ASSESSMENT OF DAM SAFETY OF COAL COMBUSTION SURFACE IMPOUNDMENTS – FINAL REPORT

**Gulf Power
Plant Scholz
Sneads, Florida**

Prepared for
*U.S. Environmental
Protection Agency
Washington, D.C.*

May 2014
Revised July 10, 2014

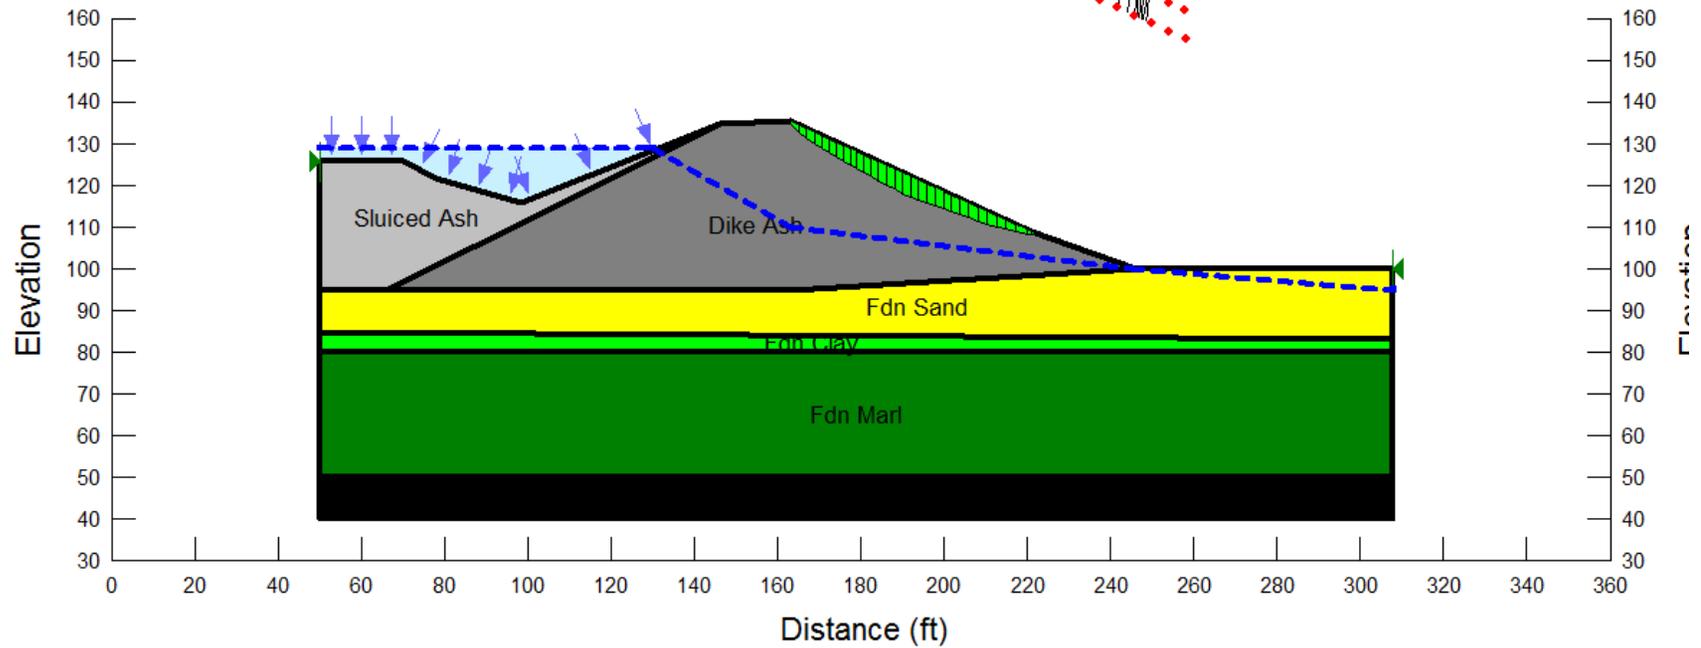
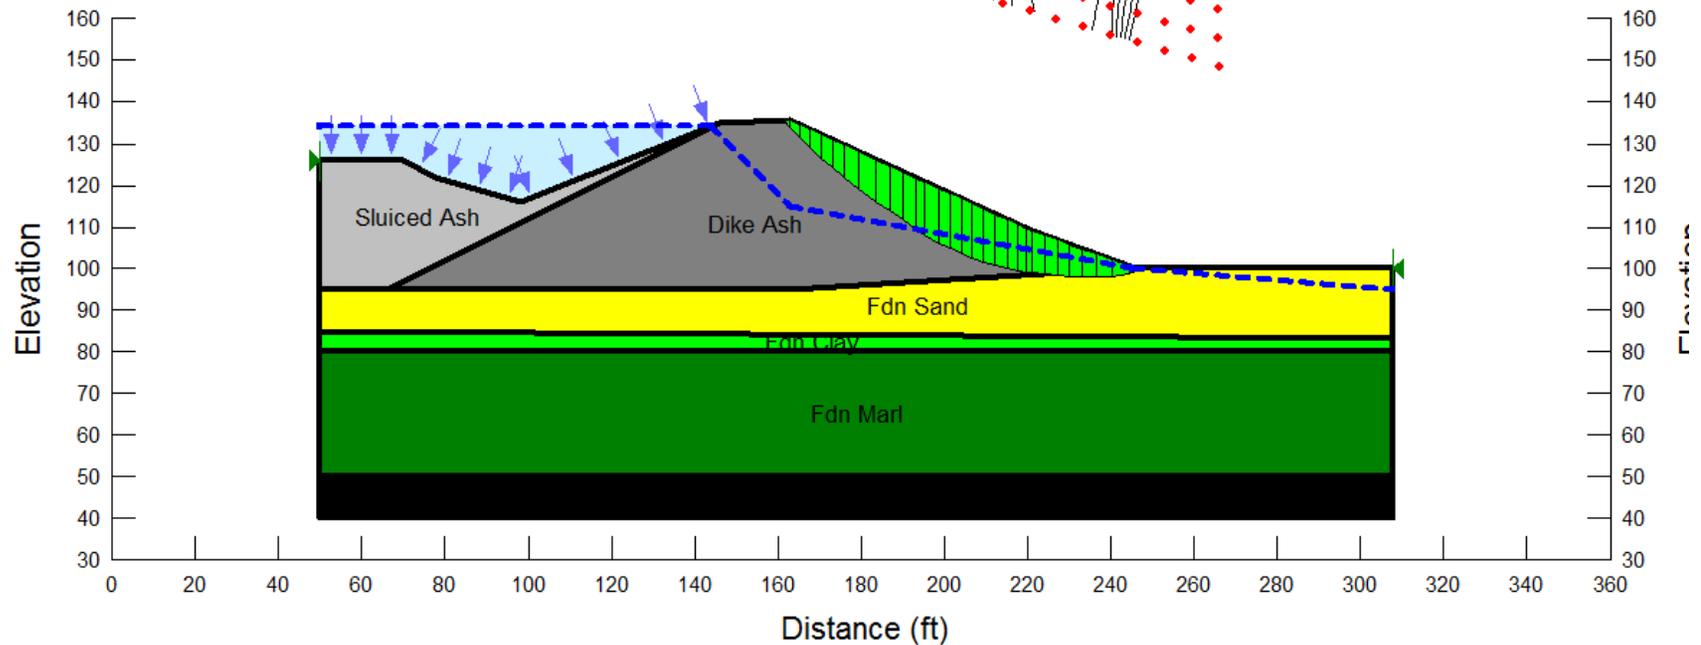
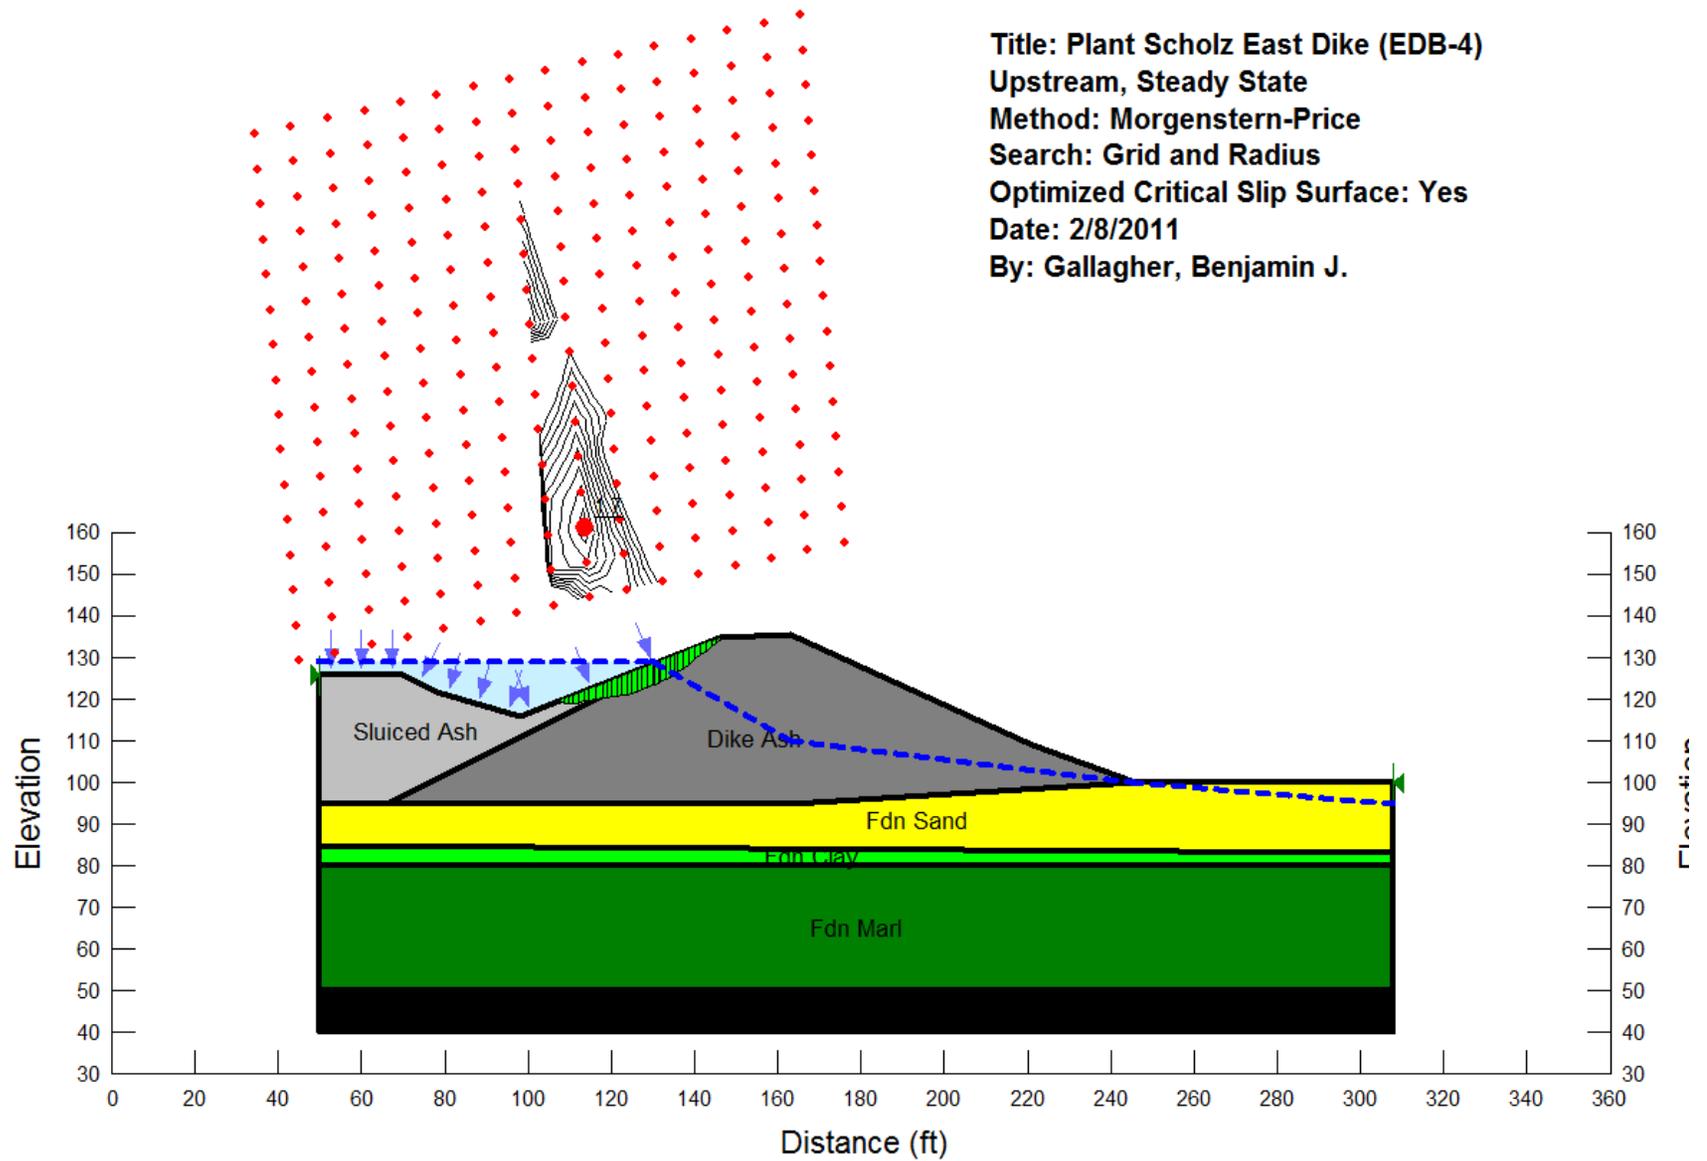
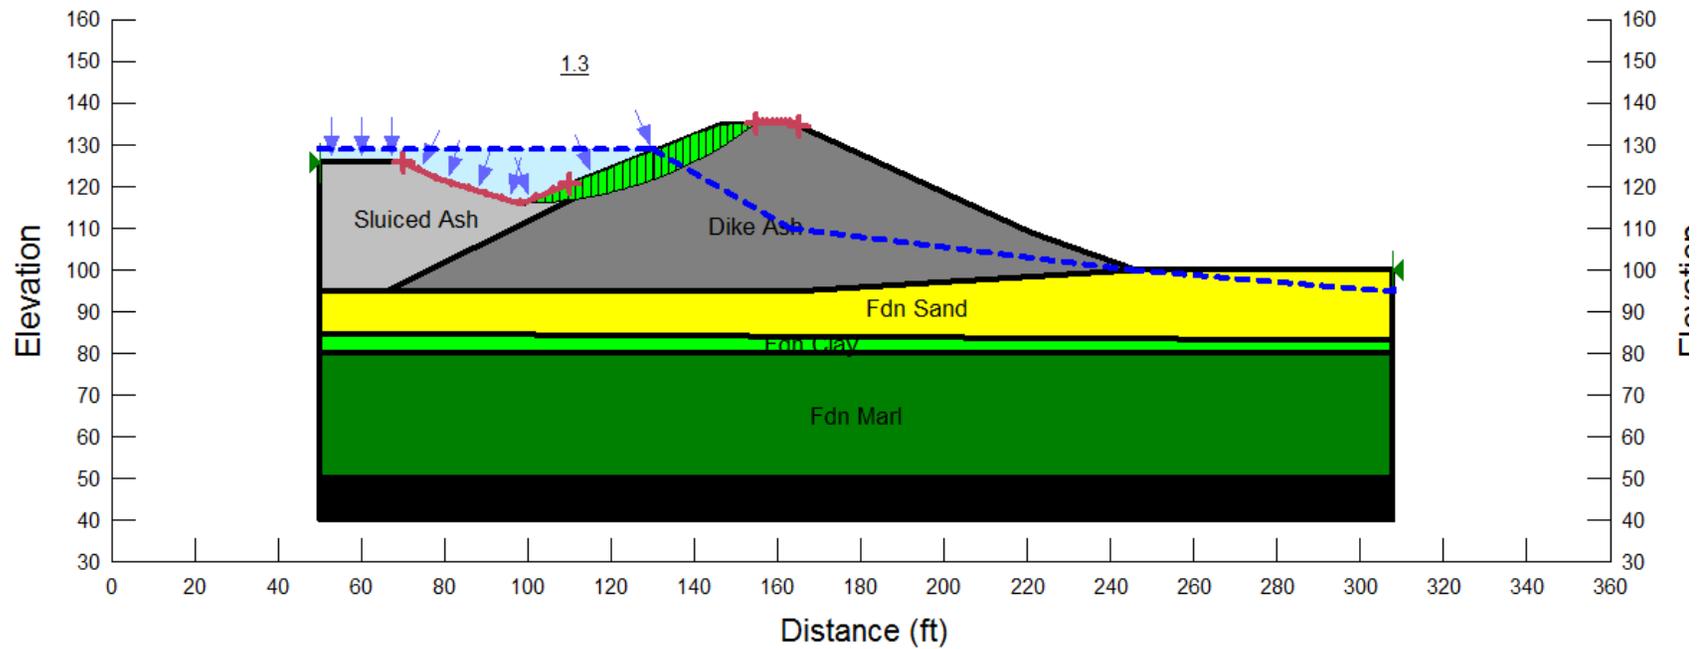
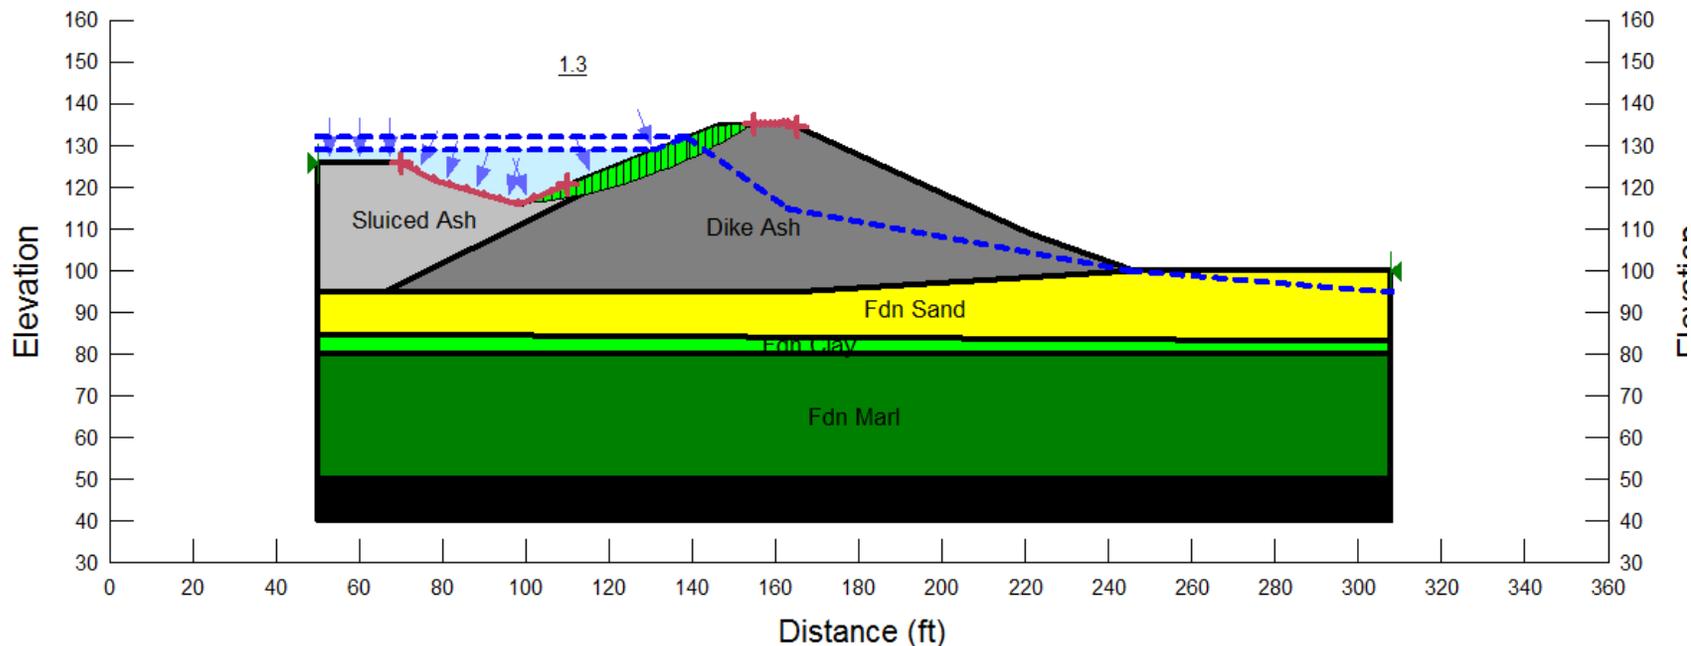
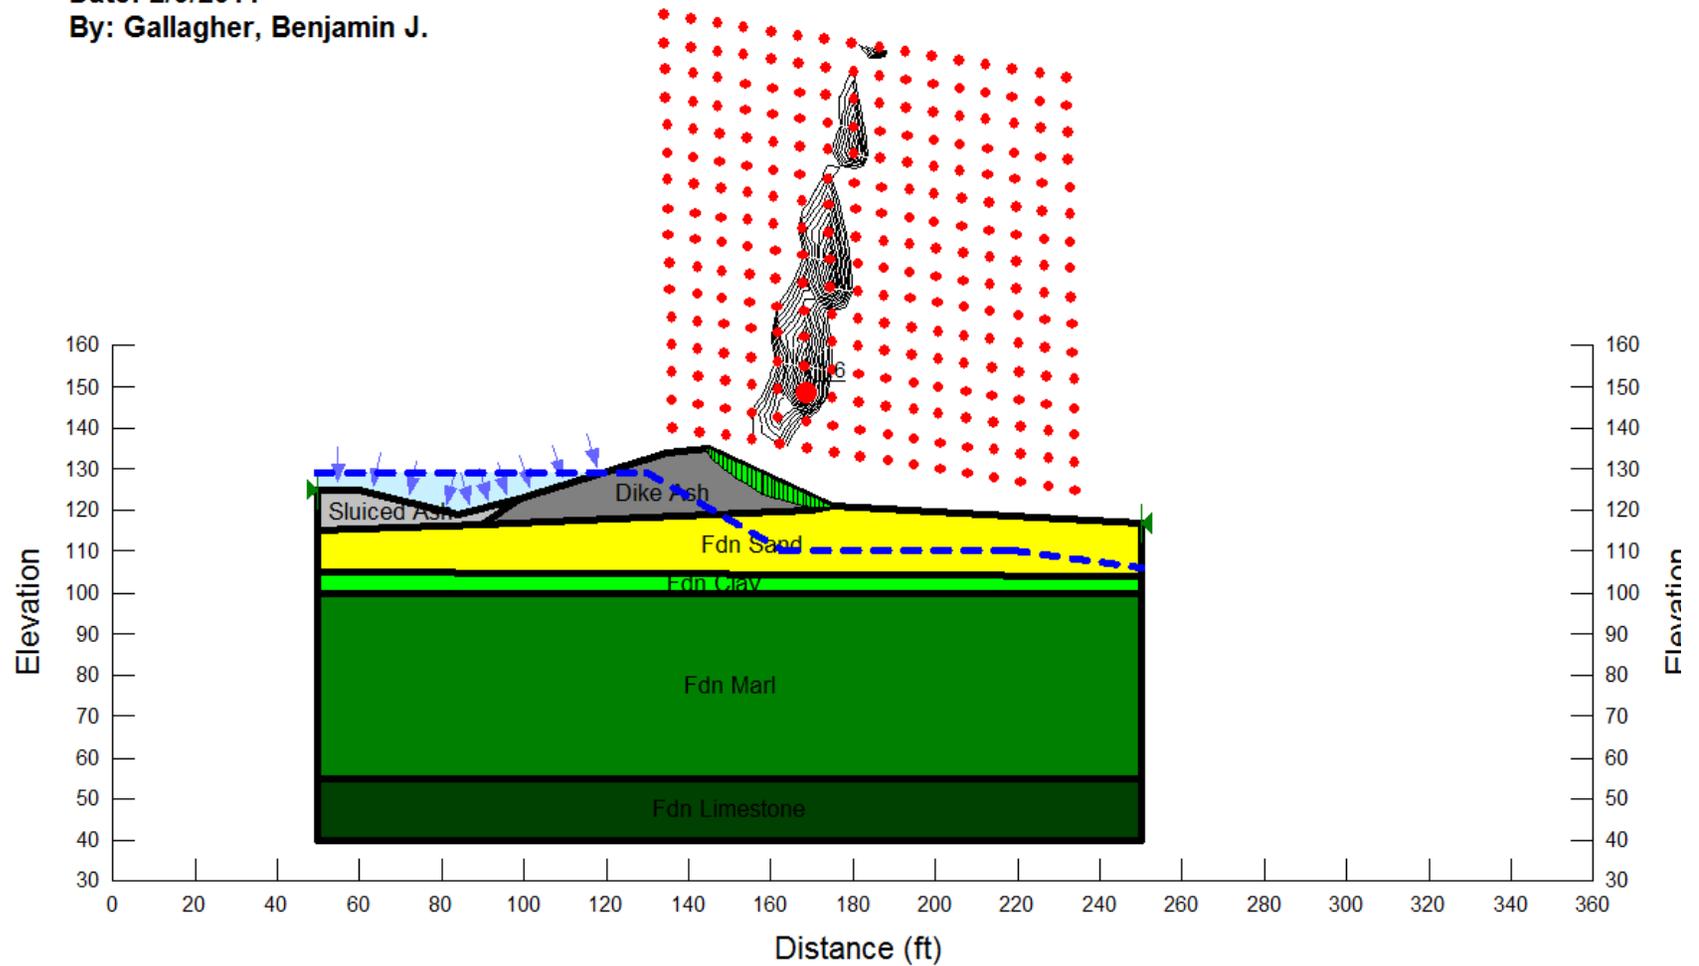
Southern Company Services February 9, 2011 report for the north and east embankments of the Upper East Pond showed a factor of safety of 1.2, under rapid drawdown loading, that did not meet the required factor of safety of 1.3. Southern Company indicates in their October 18, 2012 submittal that revised stability analyses found the upstream (interior) slopes of the pond are subject to shallow sloughing with rapid changes in water level or seismic loads. Southern Company further states the shallow depth of sloughing does not represent a hazard to the embankments, but will require prompt maintenance attention. The calculated factor of safety of 1.3 presented in Southern Company Services October 18, 2012 report for the Upper East Pond's north embankment interior slope, under the rapid drawdown case reflects acceptance by Southern Company of this condition. CDM Smith is in agreement with Southern Company Services' evaluation of the adequacy of the Upper East Pond's north and east embankments under rapid drawdown conditions, given Southern Company's commitment to prompt maintenance attention to shallow sloughing.

The stability analyses provided for the north and east embankments of the Upper East Pond and the south embankment of the Lower Pond show the required factors of safety for required loading conditions are met in all instances. Liquefaction analyses of the Upper East Pond and Lower Pond exhibit factors of safety between 0.9 and 1.4. This suggests some soft pockets may liquefy and other portions of the embankment may lose strength due to earthquake-induced pore pressure buildup. Gulf Power states in their August 22, 2012 report, they believe there is a very low likelihood of an earthquake scenario of the magnitude used for the analyses occurring over the life of Plant Scholz.
